**CERTIFIED SURVEY MAP (CSM)
& SITE PLAN APPLICATIONS**
6/14/21 Plan Commission Meeting

Planning & Zoning Report

To : Jeffrey W. Retzlaff, AICP, Planning Director/Zoning Administrator
From : Lawrence Ratayczak, P.E., Director of Public Works
Date : May 25th, 2021
Re : Trans Coil – Site Plan Review

TRANS-COIL, LLC
BUILDING EXPANSION
PROJECT NUMBER: 636.20.143
SITE PLAN SUBMITTAL
ISSUE DATE: 05.03.21

TRANS-COIL, LLC BUILDING EXPANSION
Germantown, WI
GRADING & EROSION CONTROL PLAN

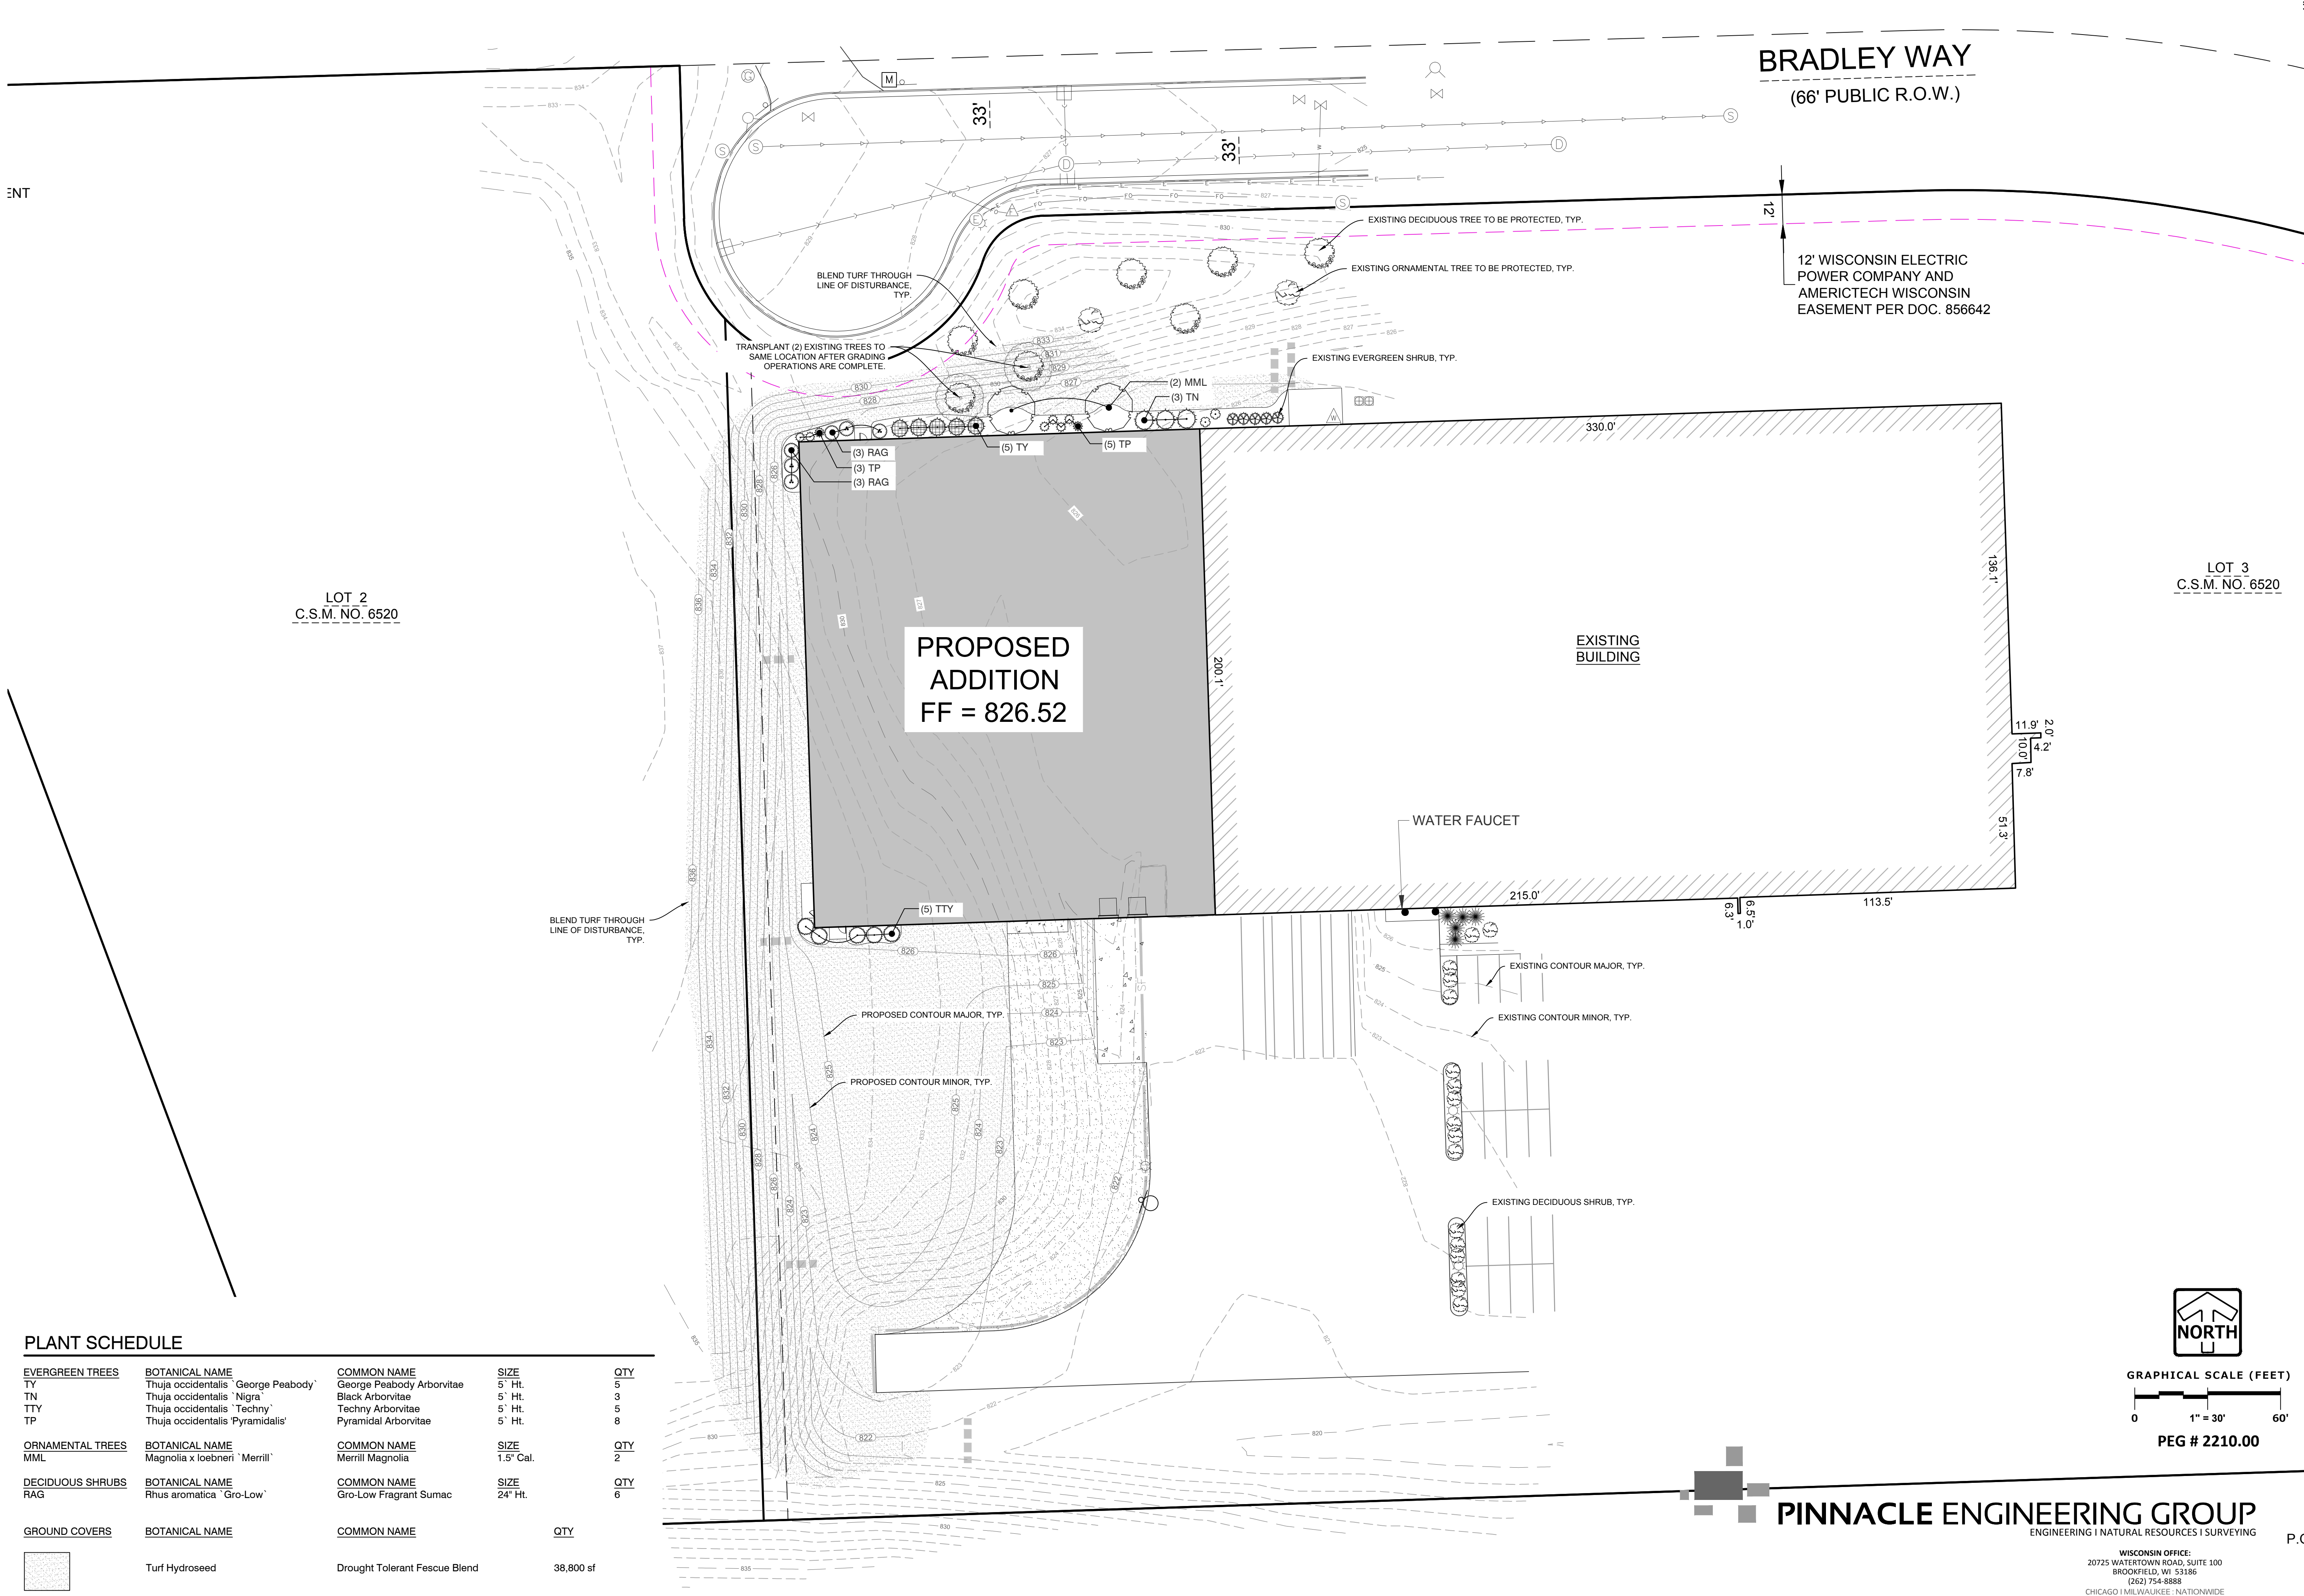
1. Add a site data table showing disturbance amounts and existing and proposed impervious surface.
2. Add an address to the titleblock
1. Plan proposes grading in the ROW of Bradley Court. Revise plan to remove proposed grading from the ROW.
2. Provide erosion control notes, including construction sequence, stabilization requirements, timeframes for stabilization and late season stabilization requirements.
3. Plan proposes a significant disturbed area and grading operation. Site is tributary to an existing regional basin. Provide a sediment trap designed per WDNR technical standards on-site to keep construction sediment from filling the regional basin.

TRANS-COIL, LLC BUILDING EXPANSION
Germantown, WI
OVERALL LANDSCAPE PLAN

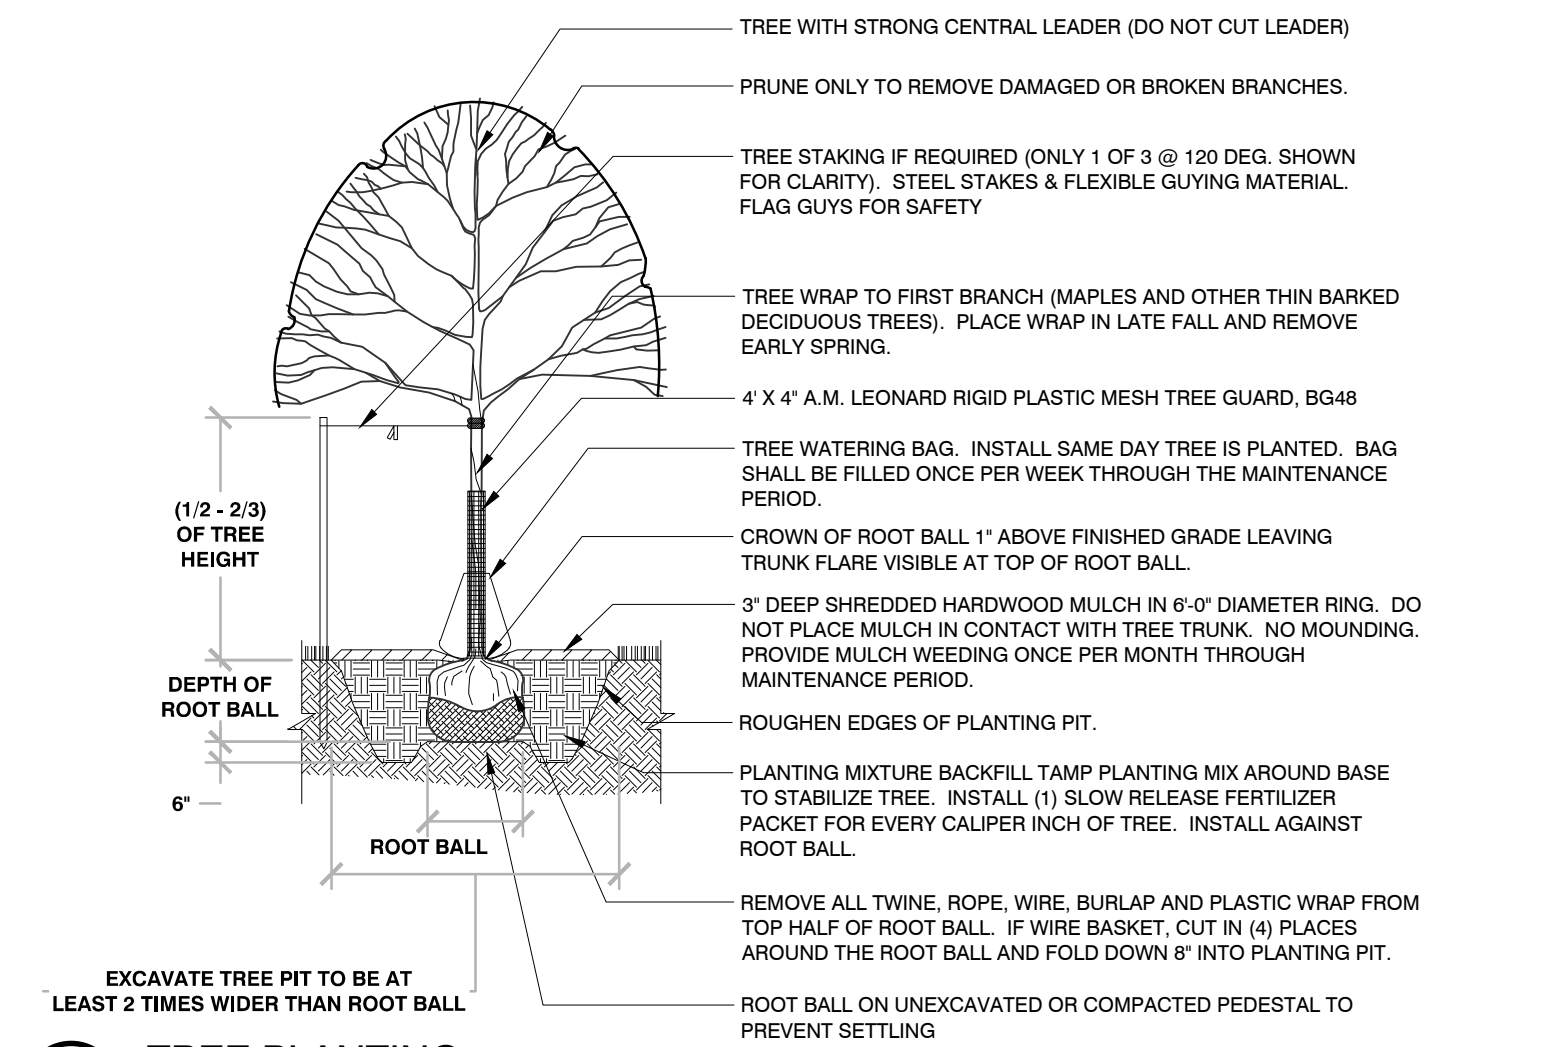
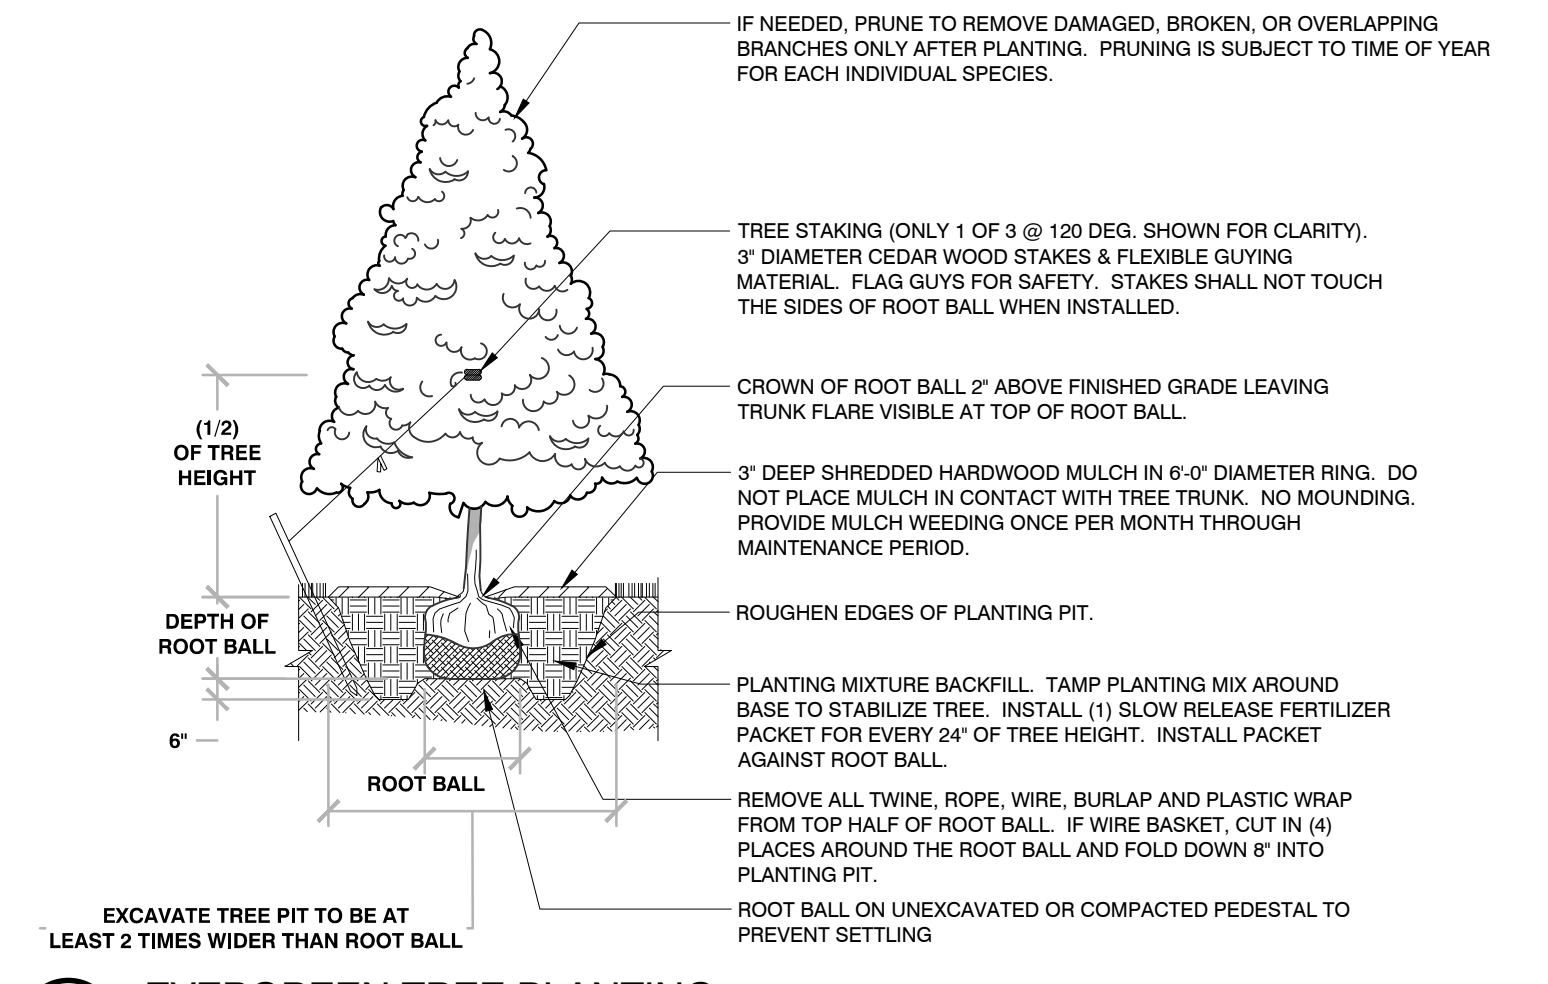
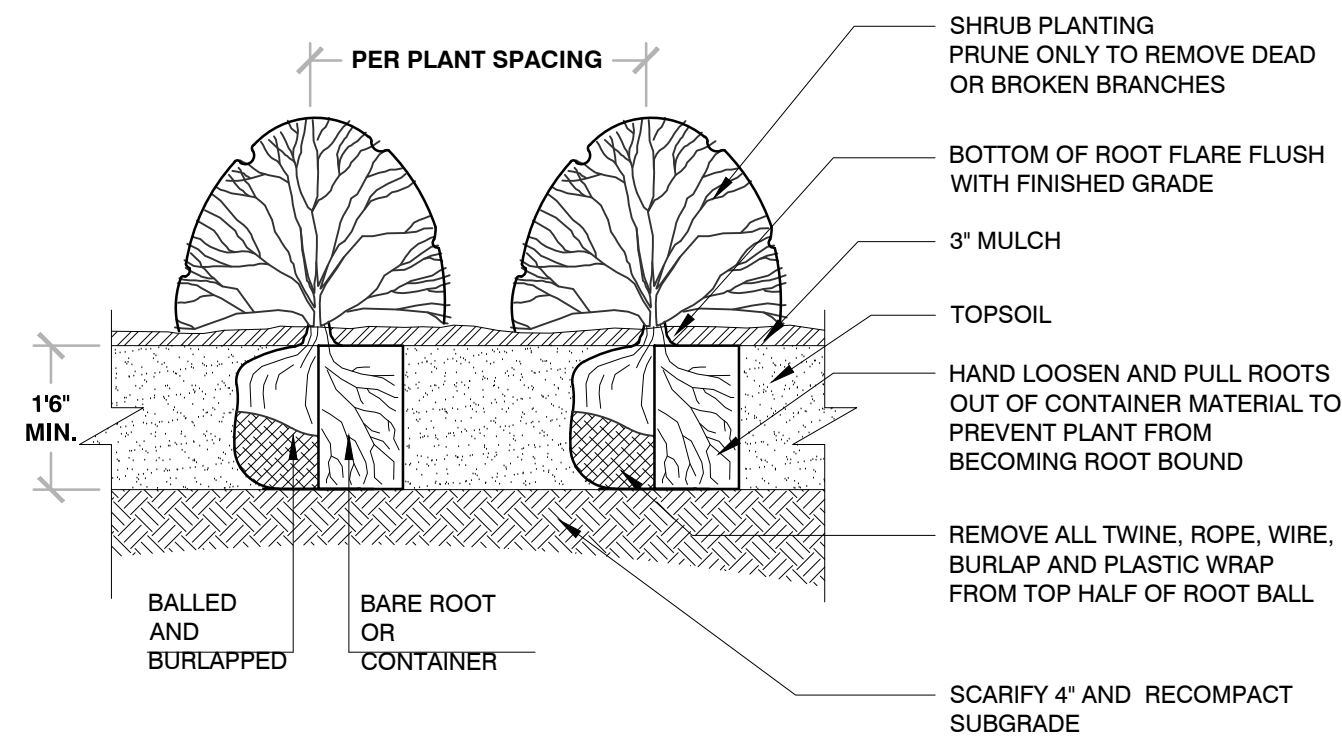
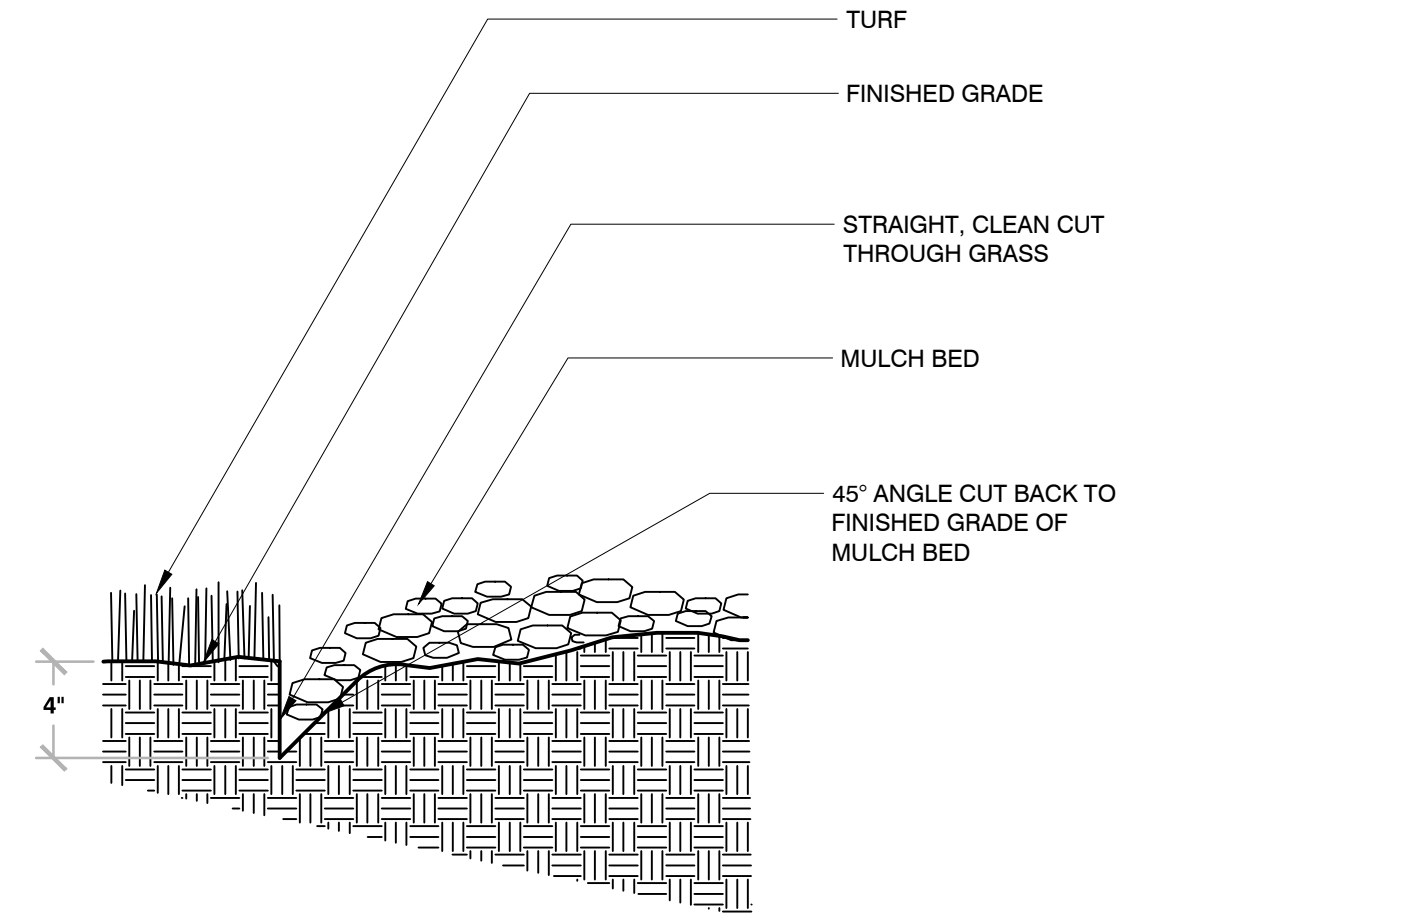
The Village Forester reviewed the landscape plan and has requested that details on protective fencing for the trees/shrubs to be preserved be added to the landscape plan.

3. The Landscape Plan shall be revised to reflect the information requested by the Village Forester. These plans shall be submitted to the Planning Department for review and approval prior to the issuance of a building permit.
